Article No. 03-3-8

- DRIVEABILITY—DIAGNOSTIC TROUBLE CODES (DTCS) P0171/P0174 STORED IN MEMORY—VEHICLES EQUIPPED WITH 3.8L ENGINE
- MALFUNCTION INDICATOR LAMP (MIL)—MIL ILLUMINATED WITH DIAGNOSTIC TROUBLE CODES (DTCS) P0171/P0174 STORED IN MEMORY—VEHICLES EQUIPPED WITH 3.8L ENGINE
- LAMP—MALFUNCTION INDICATOR LAMP (MIL) ILLUMINATED WITH DIAGNOSTIC TROUBLE CODES (DTCS) P0171/P0174 STORED IN MEMORY—VEHICLES EQUIPPED WITH 3.8L ENGINE

FORD: 1999-2000 WINDSTAR

Article 01-1-12 is being republished in its entirety to update the Service Procedure.

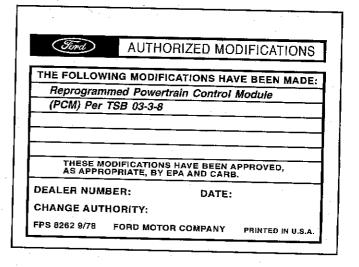
- 4. If no concerns are found, replace only Port Gaskets (9H486) and Isolator Bolt Assemblies (9S479). Do not replace any other intake parts (black plastic or aluminum) or the lower intake gaskets, 9439 and 9A424/425. Refer to Workshop Manual section 303-01, Intake Manifold-Upper.
- Check Heated Exhaust Gas Oxygen (HEGO) switching, wiring, and fuel pump pressure/volume.
